Soorty Textiles (BD) Ltd. (Extension -2)

Plot # 241-242, Cumilla EPZ, Cumilla, Bangladesh

24 December 2024

Observation-1: Inconsistencies in the design report. (Production Building)

Sectional details of P1

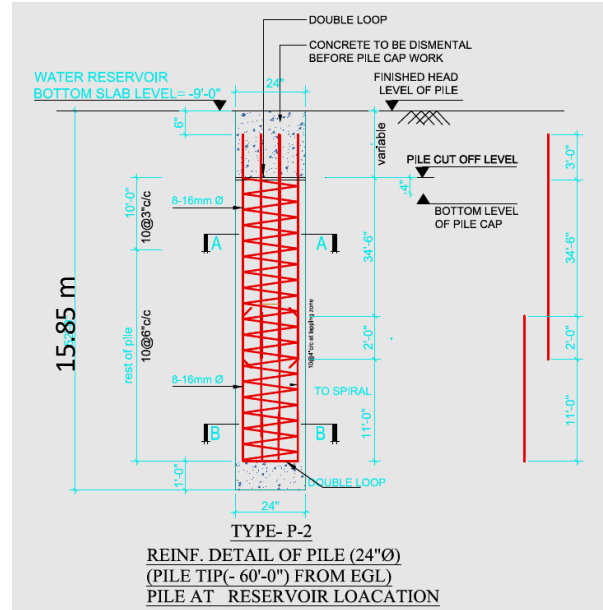
Description: As-built drawings showed two types of pile P1 (length 18.29m) and P2 (length 15.85m). But in design report, the capacity used to check pile capacity is 285 kip (each pile). Also, for SMRF consideration joint shear check was missing in the design report as per BNBC.

The building engineer is required to address the issues mentioned and revise the design report and submit the revised design documents to the RSC for review.

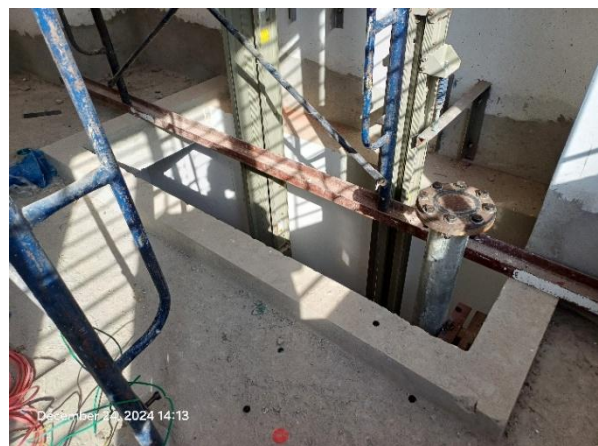
Description: Columns are susceptible to trolley impact on different floor levels. Building engineer is required to take necessary action to prevent the trolley impact with the columns.

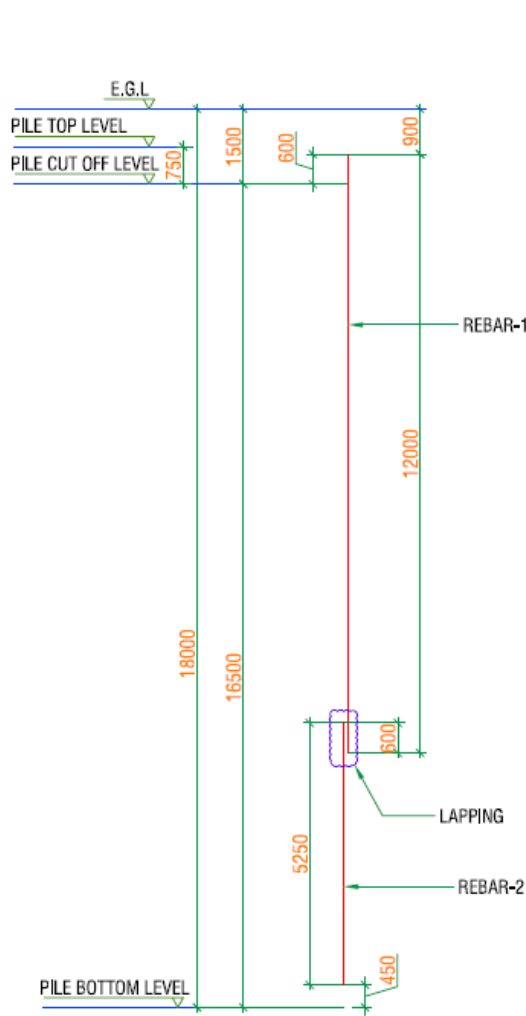
Description: Falling hazard was observed through the slab opening in the spiral conveyor room and electrical room. The building engineer is required to take necessary measures to avoid possible falling hazards.

TYPICAL LONG SEC. OF PILE-P1

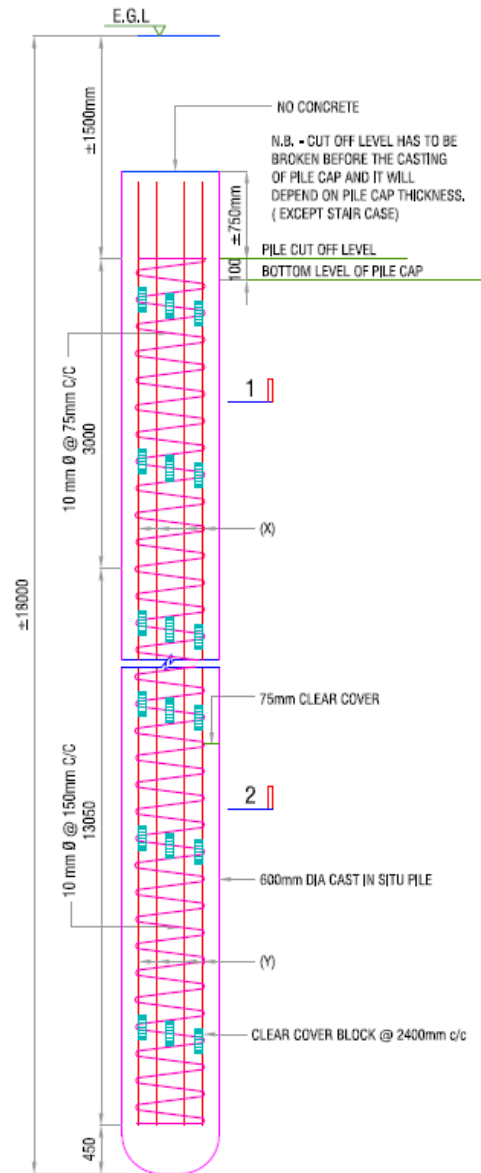
Description: The as-built drawings showed the pile length from EGL as 18m, but in the design report, it was considered 15.24m. Also, 8 no's 16mm bar was provided in the pile as per the as-built drawing, but the calculation shows 7 no's 16mm rebar. However, the pile requirement is more than one in the joint label '7', but the final pile number is one.

The building engineer is required to address the issues mentioned, revise the design report, and submit the revised design documents to the RSC for review.
